M60/M62/M66 Simister Island Interchange

TR010064

7.21 APPLICANT'S RESPONSES TO EXAMINING AUTHORITY'S FIRST WRITTEN QUESTIONS

**APPLICANT'S RESPONSES TO EXAMINING AUTHORITY'S FIRST
WRITTEN QUESTIONS**

Drawing title
**CATEGORY 3
 LAND BOUNDARIES PLAN
 SHEET 1 OF 3**

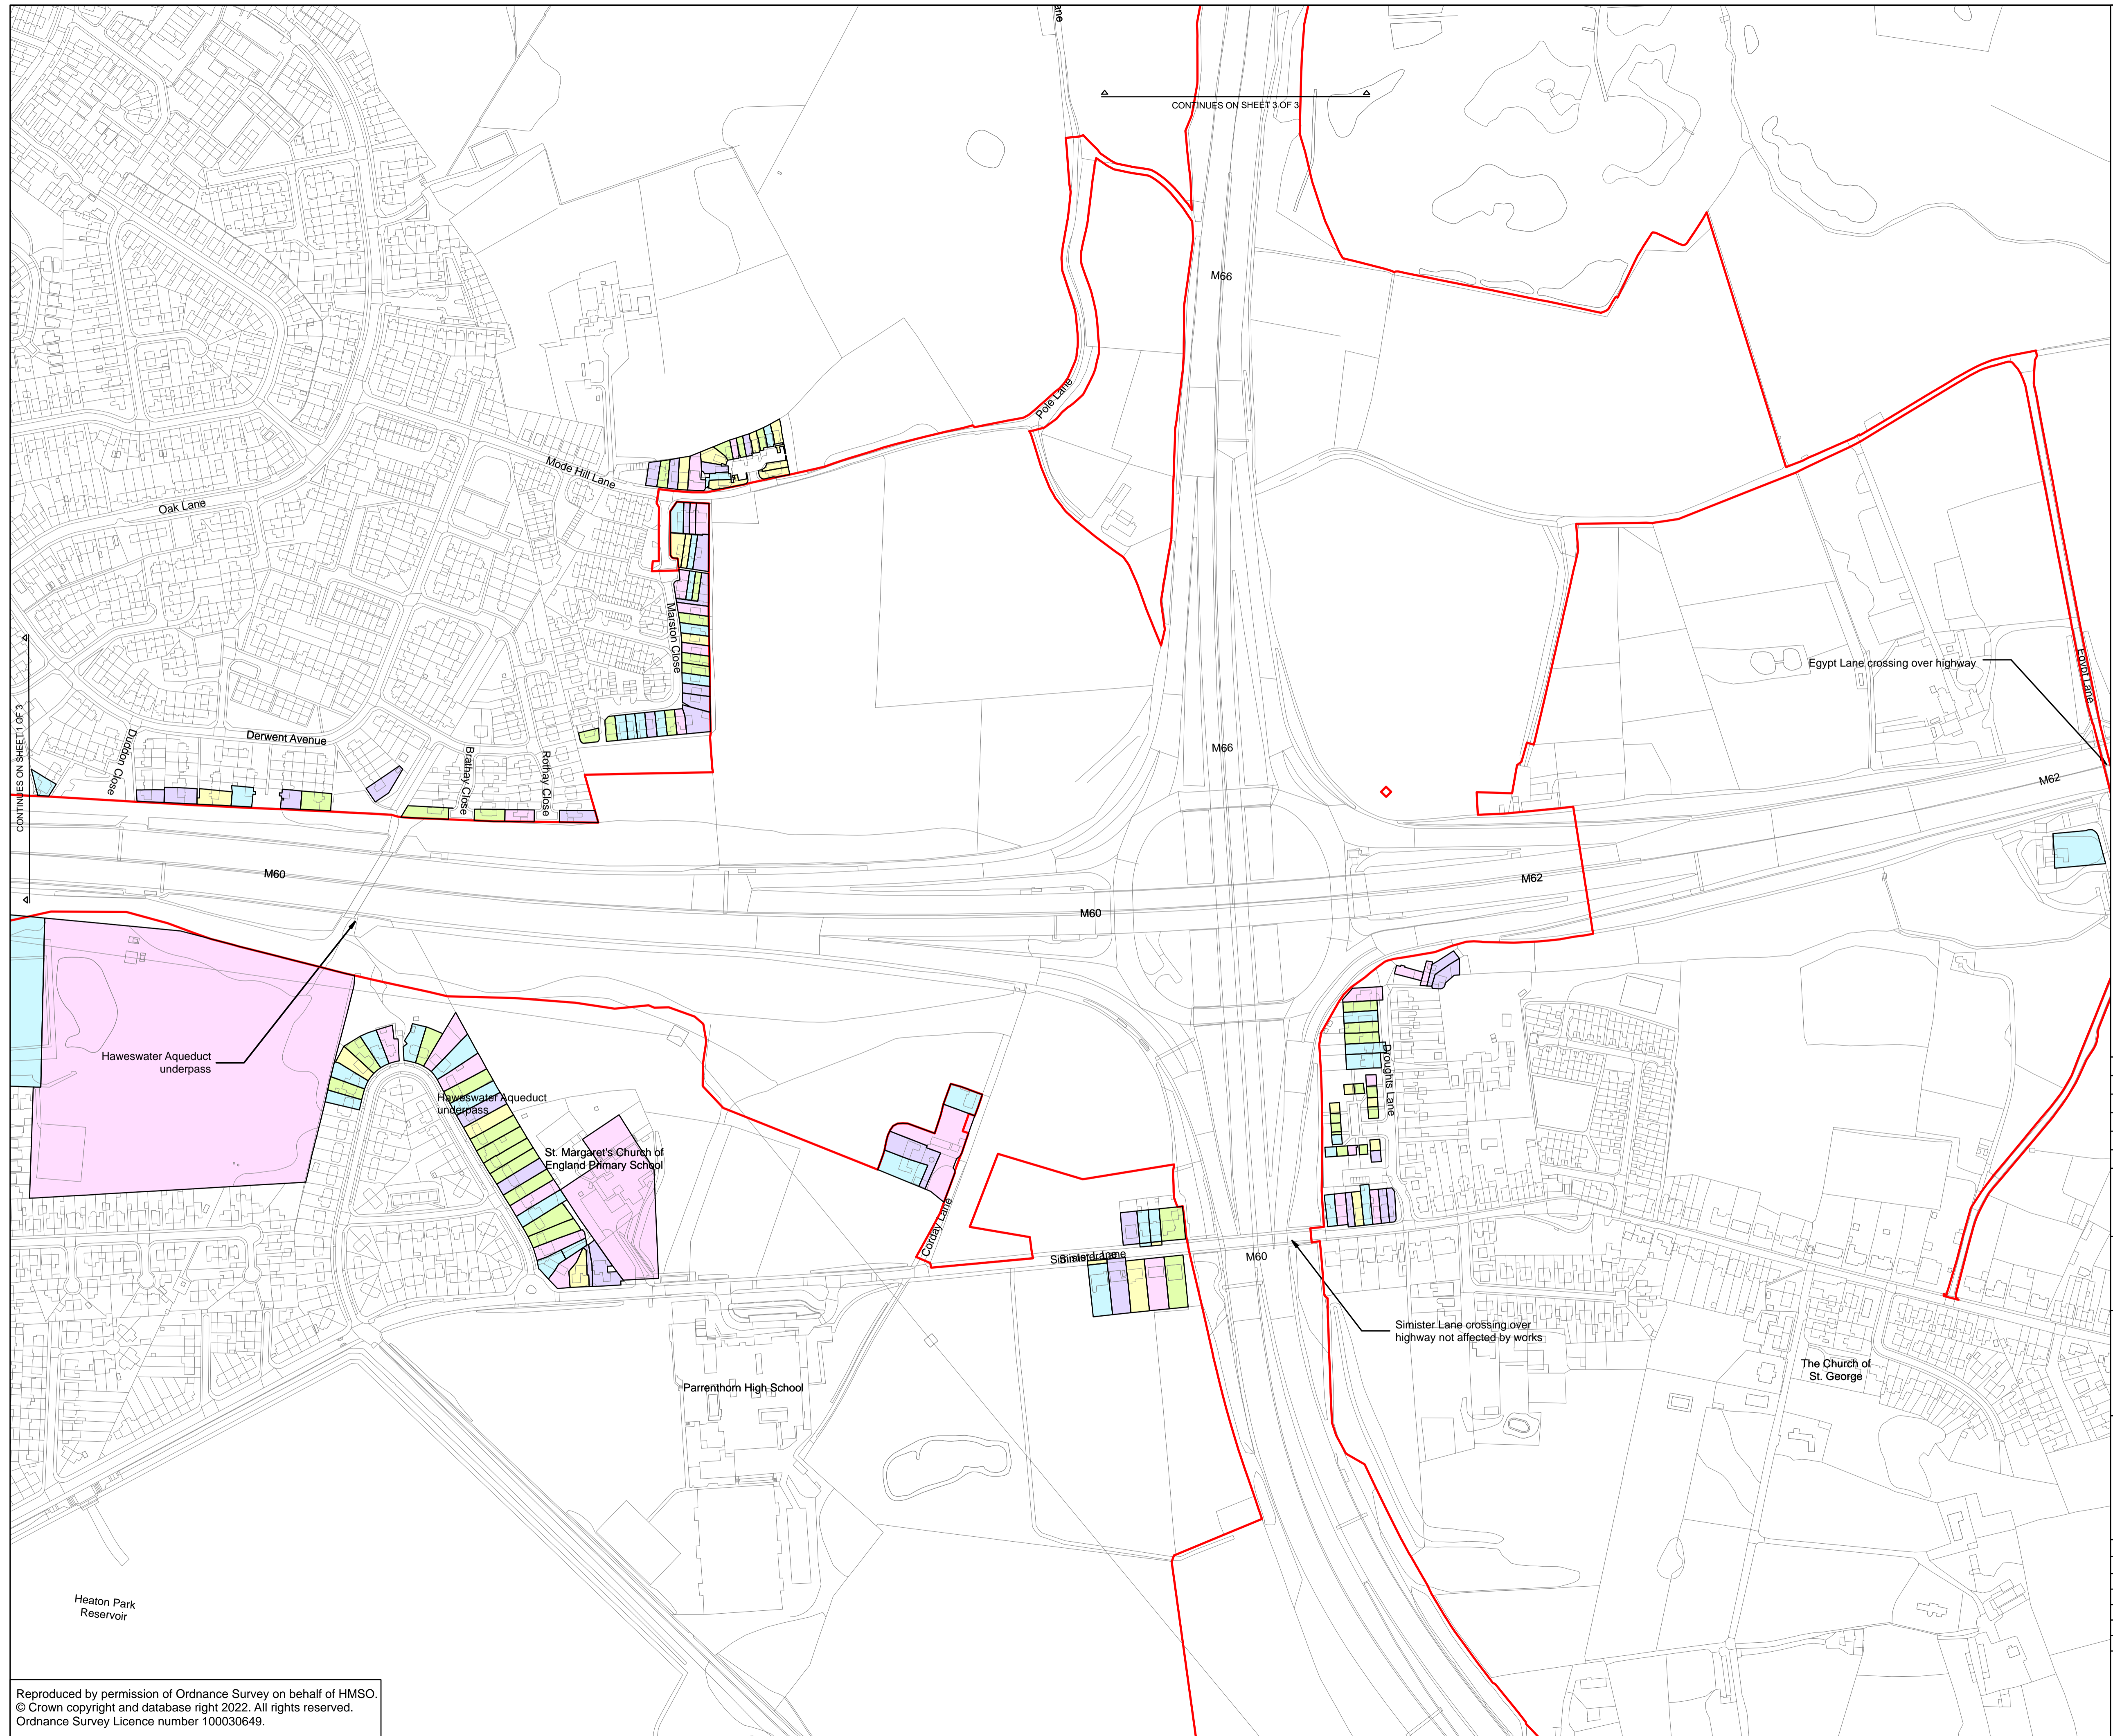
CA.1.2	Applicant	<p>Category 3 Persons</p> <p>The Statement of Reasons (SoR) [APP-019], Section 4.7 briefly covers the assessment of Category 3 persons explaining that it was based on a worse-case assessment. The process is described in the BoR [AS-010].</p> <ul style="list-style-type: none"> i. Please provide further details of the process for identifying Category 3 persons. ii. Please provide a map showing the locations of Category 3 persons. iii. Explain why the assessment can be considered 'worse-case'. 	<ul style="list-style-type: none"> i. The Applicant confirms as stated in paragraph 4.6.2 of the Statement of Reasons [APP-018] that it created a boundary of potential category 3 interests at an early stage of the preliminary design to facilitate contact referencing noted in section 4.8 of the Statement of Reasons. The boundary was also created to ensure the Applicant consulted at statutory consultation with those who may be able to make a potential claim. The boundary was applied to the latest HM Land Registry information and other mapping systems such as HM Ordnance Survey information. The boundary was assessed by Applicant and was informed by advice from the appointed District Valuer. The factors considered in that assessment are described in section 4.7 of the Statement of Reasons [APP-018]. This boundary was refined during the pre-application stage to take account of the preliminary Scheme design that forms the application for development consent. The Applicant notes that some category 3 interests were retained towards the late stages of application development on a precautionary basis. ii. A plan showing the boundary of the Category 3 persons that has been used when producing the application has been provided in Appendix B of this document. The Applicant notes that the plan does present some areas which may on first inspection appear to be omitted from the plan. Category 3 persons are located outside the Order limits and the plan does not show Category 1 and 2 interests which in some areas incorporate a property which would otherwise be a category 3 interest. The Applicant has not identified any potential category 3 persons where more minor works are proposed in the northern areas of the scheme presented on sheet 3 of the Land Plans and beyond. iii. The assessment of the category 3 boundary is considered 'worse-case' as it includes persons beyond the extent of the likely significant effects identified during the development of the environmental impact assessment, as stated in section 4.7 of the Statement of Reasons [APP-018].
